Design Change of the Z3-axis Processing Point Temperature Sensor [Optional Accessory] of the DGP8761 (Dry Polish Specification) Due to Production Stop

DGP8761 (Dry polish specification)

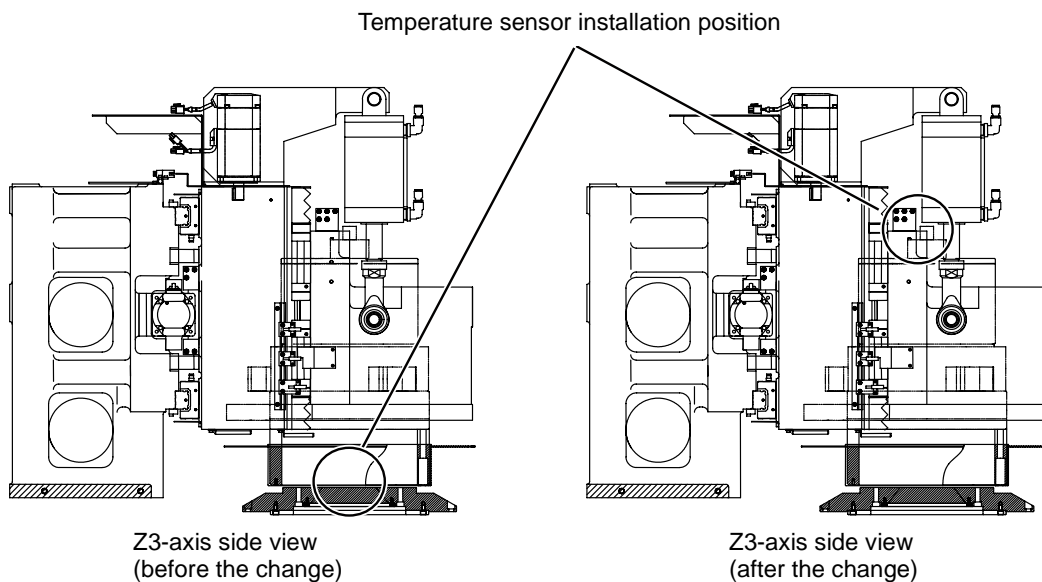
- The parts for the temperature sensor, wiring/piping and mounting are changed.
- The temperature sensor installation position is changed from the inside of the flange to the upper part of the spindle (in order to improve the maintenance performance and reliability).
- There is no change in any function or specification.

New P/N: FNNG-010003-** (Processing Point Temperature Sensor ASSY)
